ADDENDUM NO. 2

February 9, 2026

Southport High School Addition & Renovation Phase 1 (Activity Center Addition & Wrestling/Center Plant Renovation)
971 E. Banta Road
Indianapolis, IN 46227

WINDOW SCHEDULE

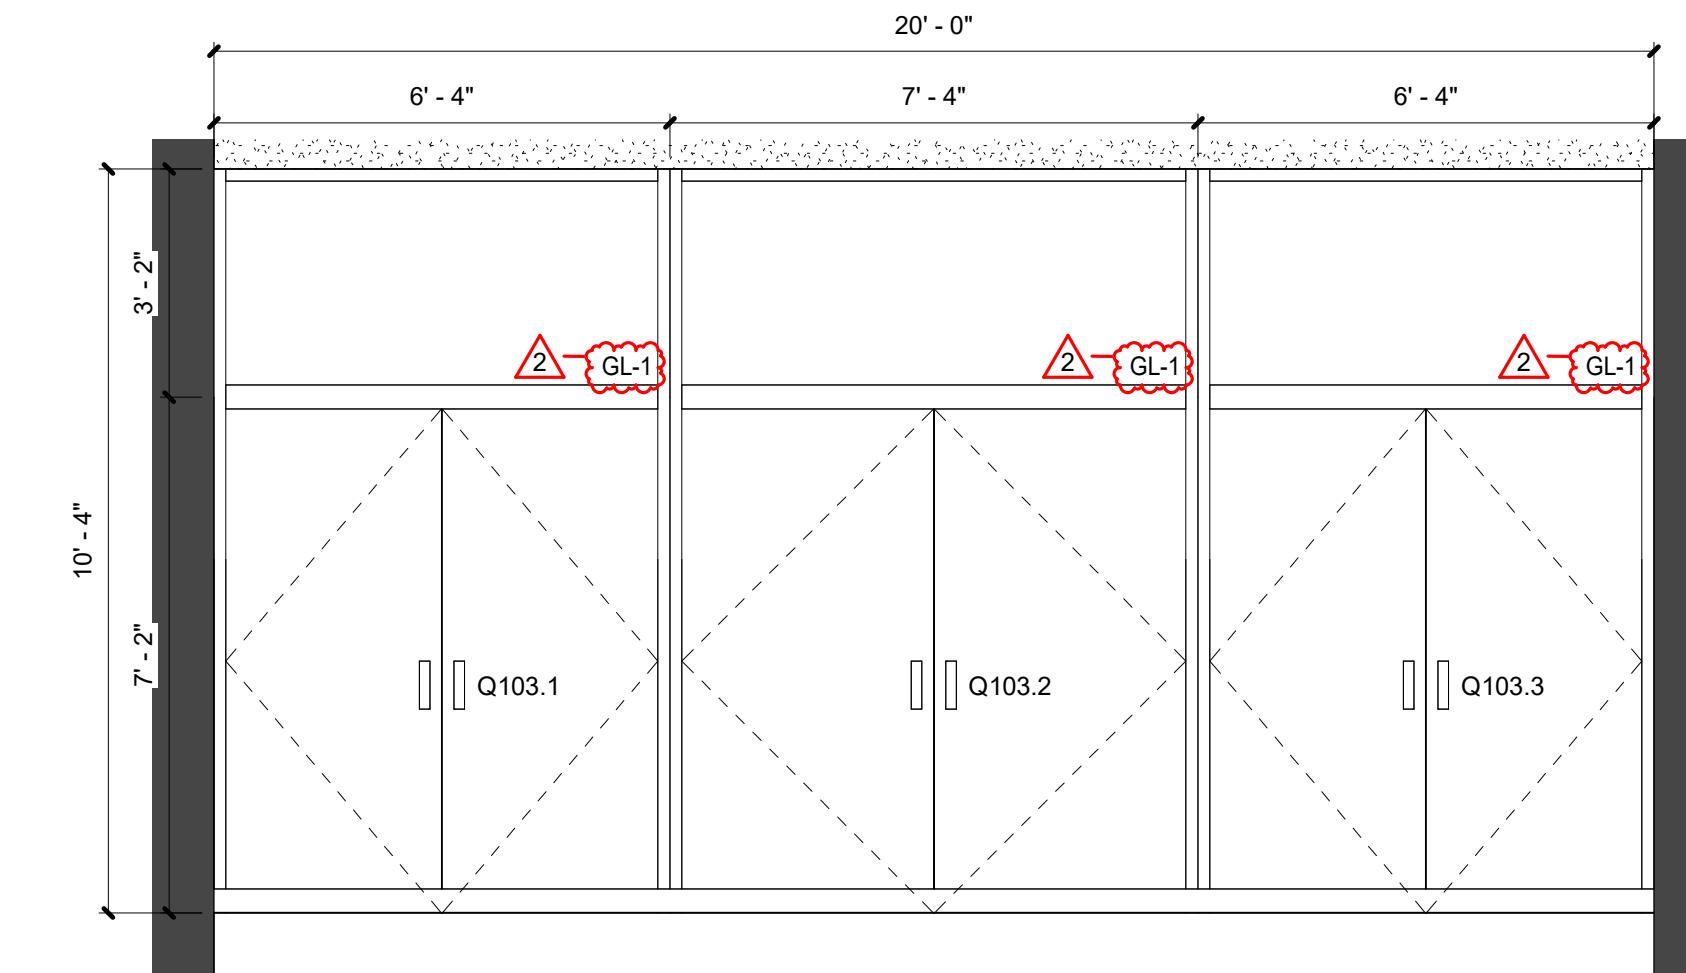
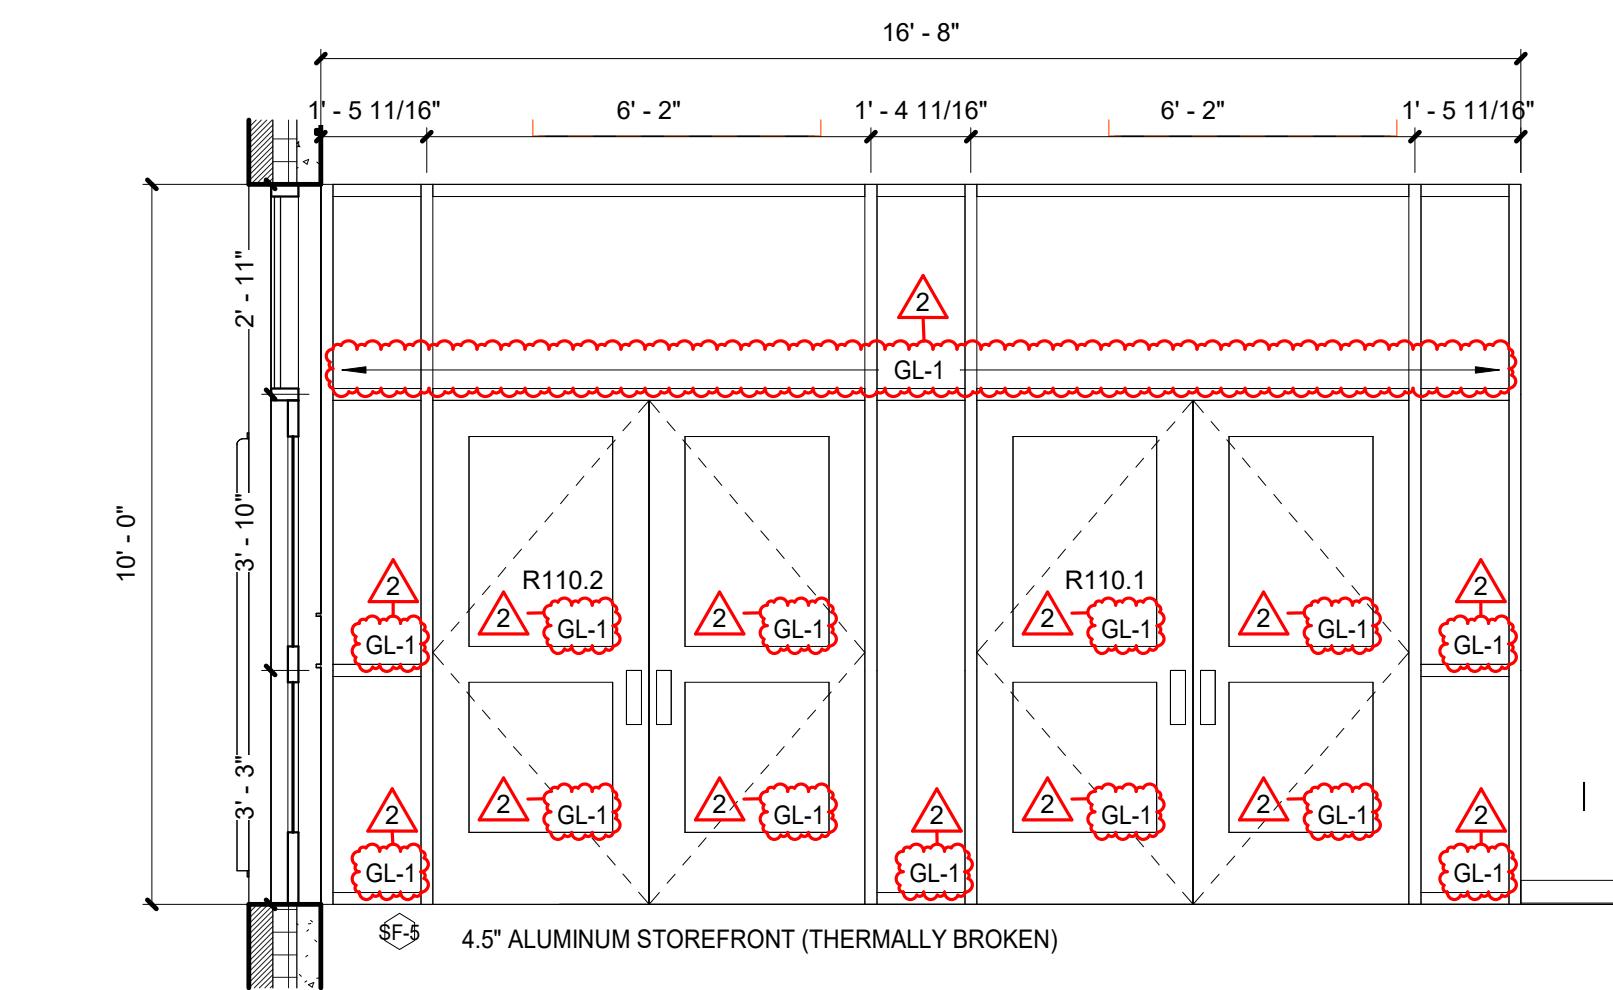
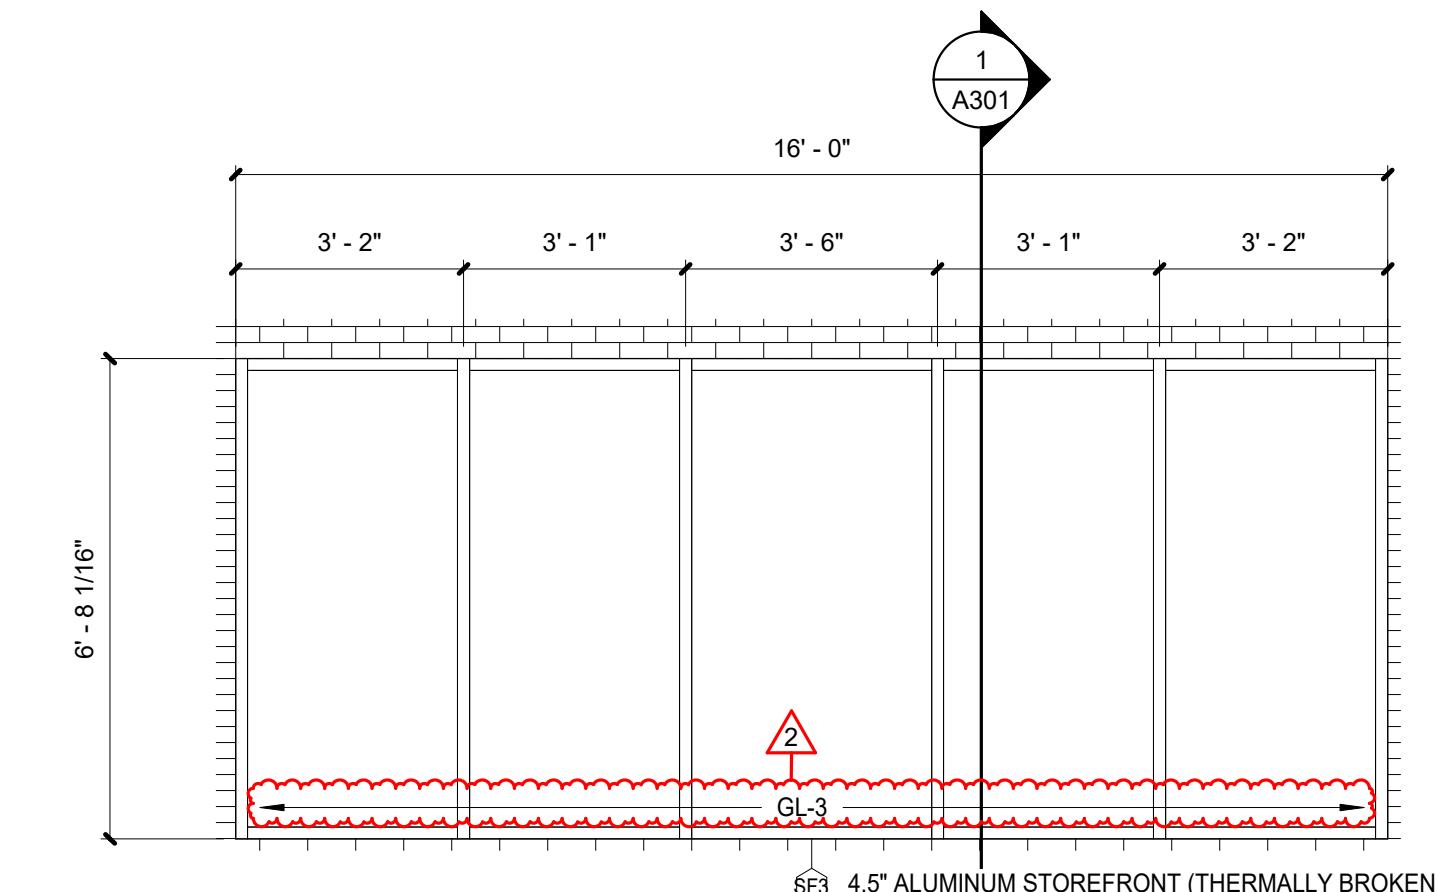
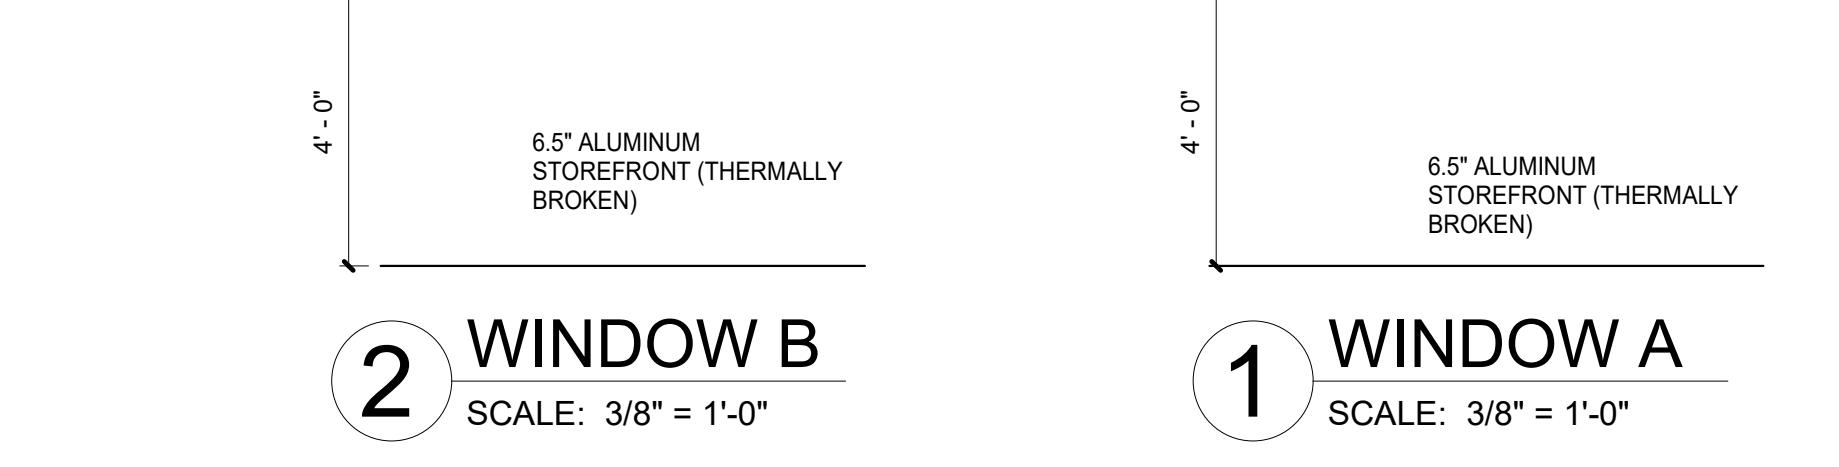
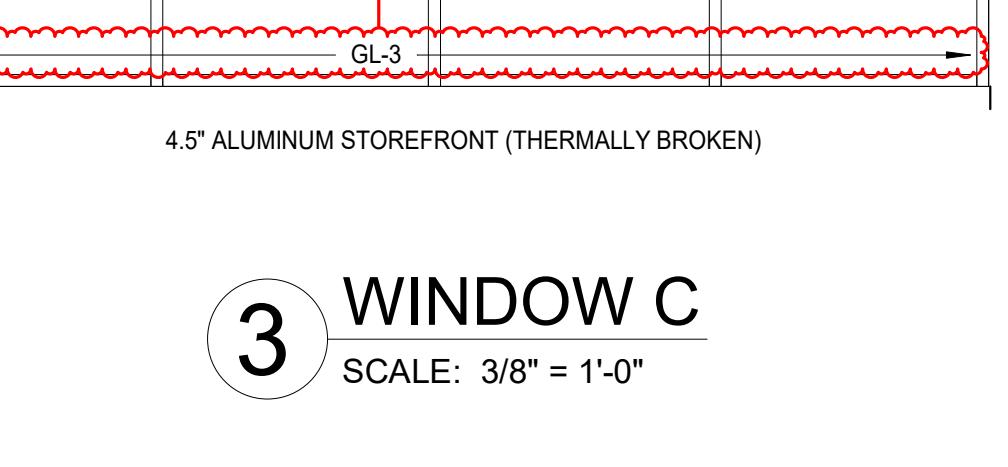
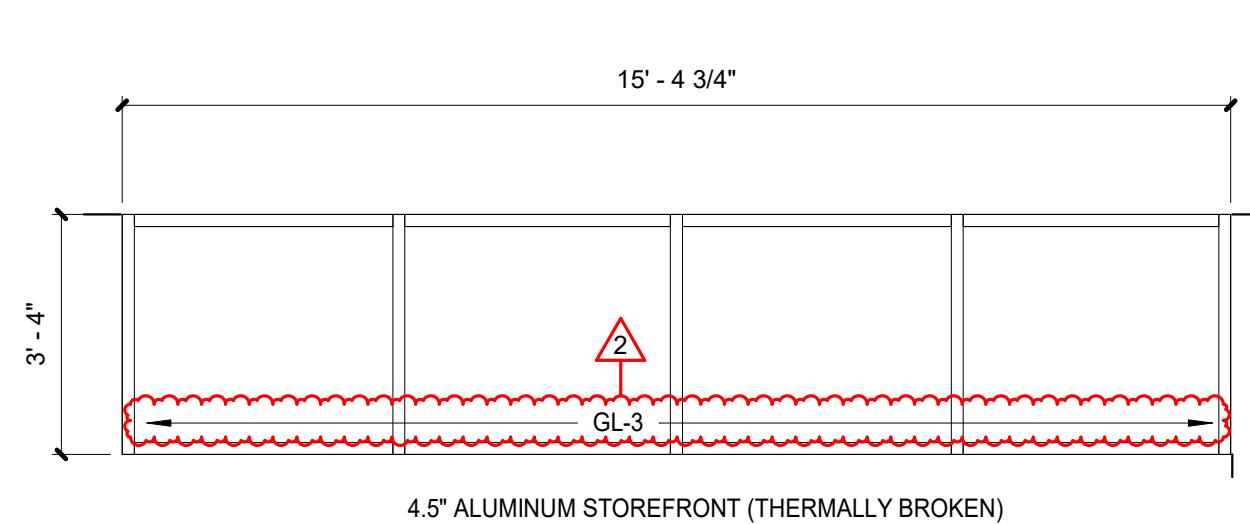
- Add glazing schedule to sheets
- Identified glazing types at each window elevation.
